Access Compliance Report Public Rights-of-Way (Curb Ramps)

Main Street: N/A Cross Street: ANTONIO_PKWY Location: SW

ADA ID: RPRK220223140635 Ramp Type: Type 1 - Perpendicular Initial Pass/Fail: Pass Overall Compliance: No Severity Score: 10

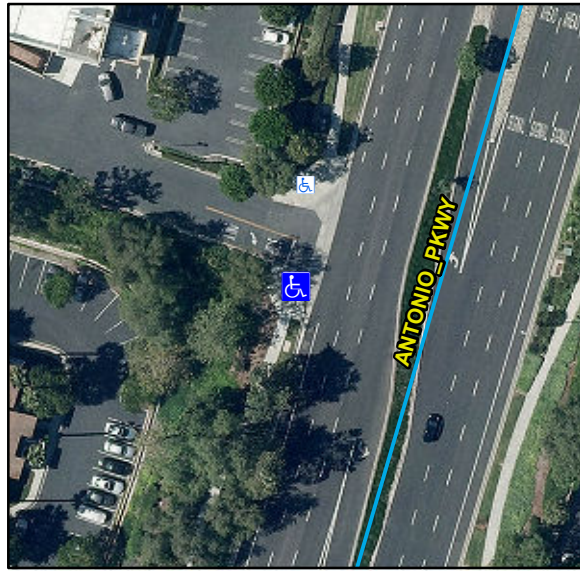
Possible Solutions:

Install Detectable Warning System.

R305, STD 1115
